## Regis Belrose Residential Aged Care Facility – 181 Forest Way, Belrose

### Council Engineering OSD Referral Response

This letter is prepared in response to the Northern Beaches Council (Council) request for additional information (RFI) engineering referral letter dated 15.11.2024.

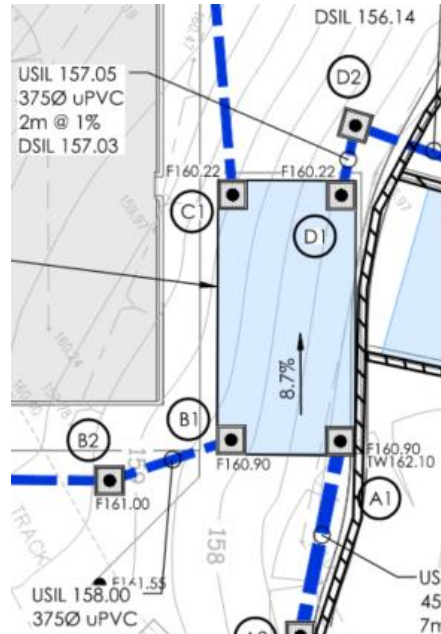
We have reviewed the current design against the Council's Water Management for Development Policy and do note that a minor inconsistency is apparent. The policy states that the pre-development impervious area is to be 0% and therefore considered to be back to its 'natural' state, ie grass and trees.

Our current design has a pre-development impervious percentage of 13% which considers the existing house and pavement.

We have therefore amended the design to be consistent with the Council policy, refer update drawing C512 in Appendix A.

Notwithstanding this change has an insignificant effect on the proposed OSD design. The pre-development flows are still maintained within the proposed OSD volume of 125m<sup>3</sup> with minor adjustments to the tank configuration.

- Orifice diameter adjusted to 245mm, previously 250mm
- Wier wall height adjusted to RL159.47, previously RL159.40

Figure 2 – Drains model

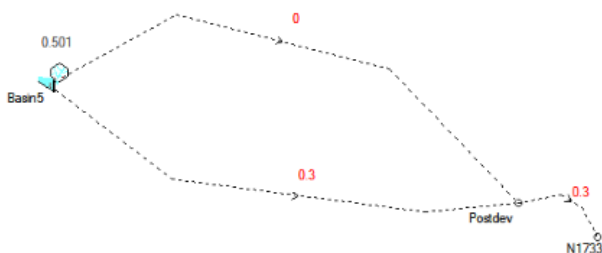
The ACOR report states that an overflow route from the tank was used to model a staged dual orifice discharge relationship, refer image below, rather than modelling this in detail using dual orifice nodes in DRAINS. This staged relationship calculation has not been provided in their report or drawings and therefore cannot be verified by Entec. The design also appears to restrict the 1% AEP flows more than the required pre-development flows which could account for the additional storage volume needed to detain the flows.

Extract from ACOR drawing C1.05 showing OSD section detail

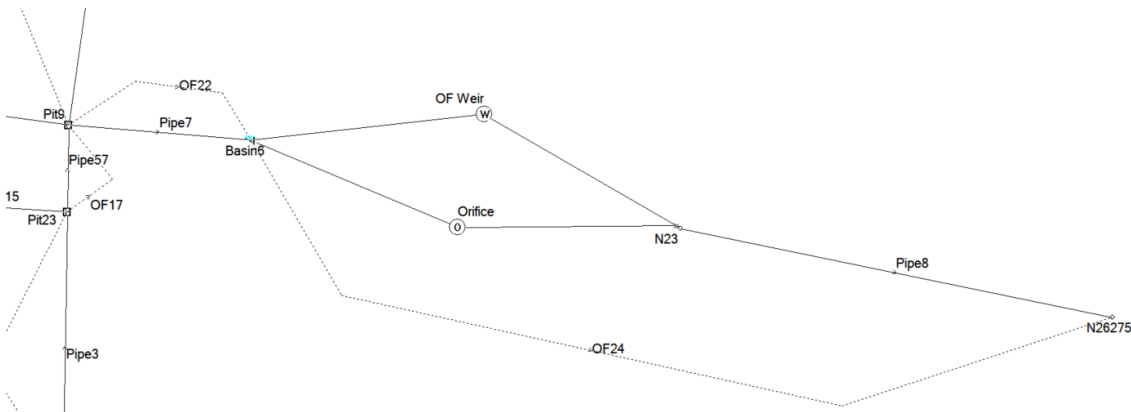
It is also worth noting that even though the ACOR report states a dual orifice staged discharge relationship was used to model the OSD, this is not reflected on their OSD details sheet, refer below. The detail seems to indicate only a single low-flow orifice outlet with an emergency overflow from the tank set at the 1% AEP level. If the OSD has been designed as a single orifice then this would likely account for the significant increase in volume.

Entec DRAINS model with low-flow orifice and high-flow weir design

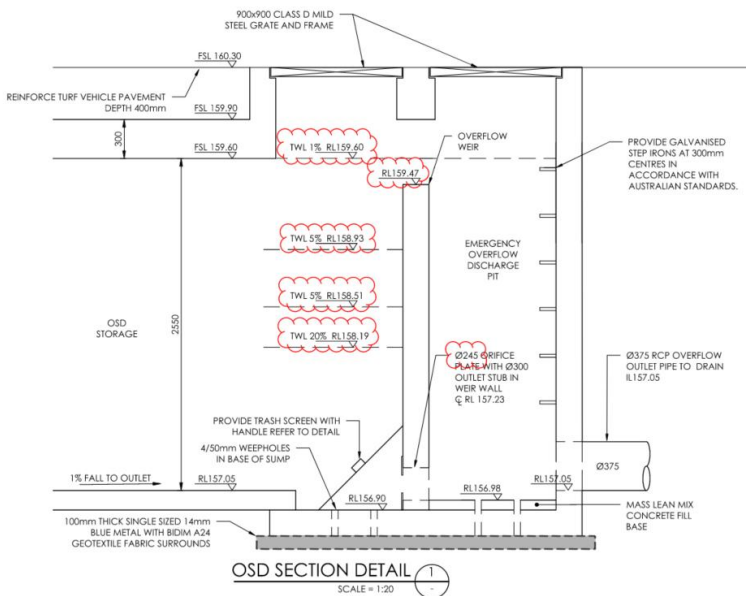
The Entec OSD design incorporates a staged discharge by utilising a low-flow orifice, designed restricts flows during all storm events up to the 5% AEP, and a high-flow weir that allows water to flow over the weir during the 1% AEP. The DRAINS model has been detailed designed and models each pit and pipe with sub-catchments which subsequently discharges to the OSD. The OSD has been modelled using the full unsteady analysis within DRAINS which allows us to accurately model a staged discharge arrangement by utilising orifice and weir nodes. This allows us to clearly show the effect of both a low-flow orifice and a high-flow weir. The DRAINS model has been provided for Council review and subsequent approval.
